**CITY OF MCMINNVILLE  
PLANNING DEPARTMENT**  
231 NE FIFTH STREET  
MCMINNVILLE, OR 97128

**DECISION, CONDITIONS, FINDINGS OF FACT AND CONCLUSIONARY FINDINGS FOR THE APPROVAL OF A LANDSCAPE PLAN AND STREET TREE PLAN FOR THE BAKER CREEK NORTH SUBDIVISION**

- DOCKET:** L 12-19 (Tree Removal, Landscape Plan and Street Tree Plan)
- REQUEST:** Approval of a Tree Removal, Landscape Plan and Street Tree Plan for the Baker Creek North subdivision.

Open Space 'Tract I':

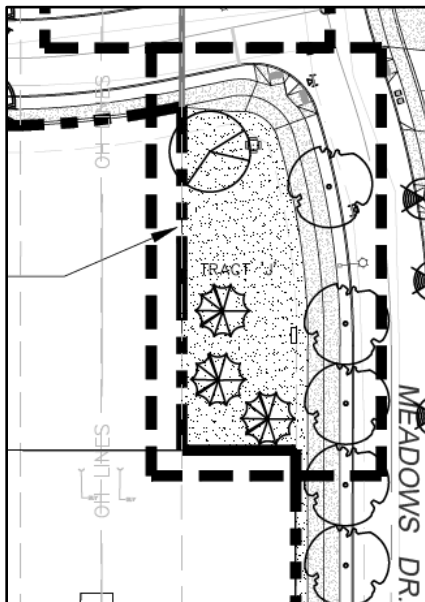
Based on comments from McMinnville Water & Light, trees surrounding the electric substation should be limited in height to 25 feet. A condition is included limiting the height of any trees located in Open Space Tract I to a maximum mature canopy height of 25 feet.

Open Space 'Tract K':

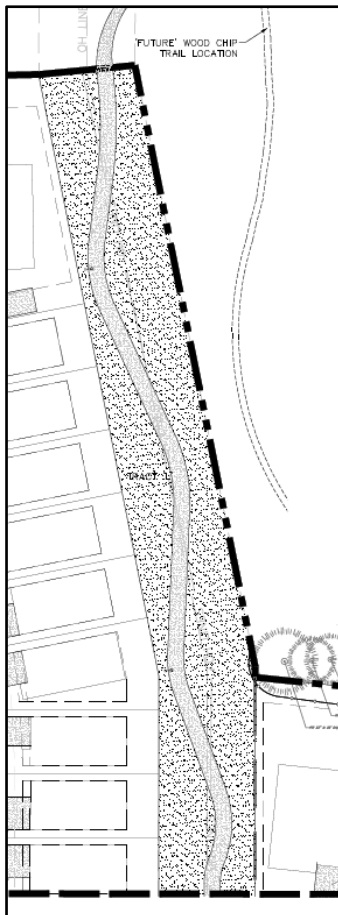
Sunburst Honey Locusts grow approximately 40 feet tall and wide. Based on comments from McMinnville Water & Light, trees in Tract K should be located such that no canopy encroaches into the transmission easement. A condition is included limiting the height of any trees in Open Space Tract K to a maximum mature canopy height of 40 feet and to locations such that no canopy encroaches into the transmission easement.

Open Space & Access Easement 'Tract L':

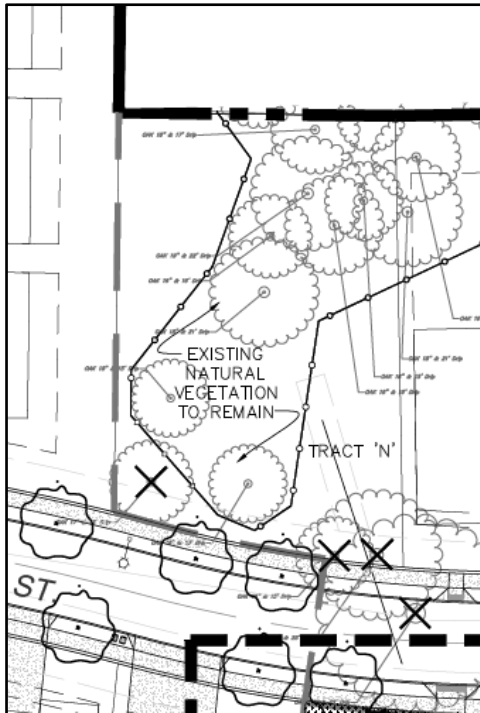
Tract L is the northernmost extension of the Westside Bicycle/Pedestrian Greenway through the planned development and BPA easement, leading to the proposed park dedication. A 10 foot wide multi-use trail is proposed, meandering through an open lawn area below overhead electric transmission lines. Because of the overhead lines, trees in the Access Easement are not recommended. Based on McMinnville Water & Light comments, conditions of approval are included to restrict the placement of trees inside Open Space & Access Easement Tract L, limiting the height of any trees in adjacent to Tract L to a maximum mature canopy height of 40 feet and to locations such that no canopy encroaches into the transmission easement, and to ensure no picnic table or other public amenity blocks access to transmission facilities.

Additionally, no street trees should be located within the public right-of-way in the transmission line easement, where they would be in incompatible with electrical transmission lines overhead.
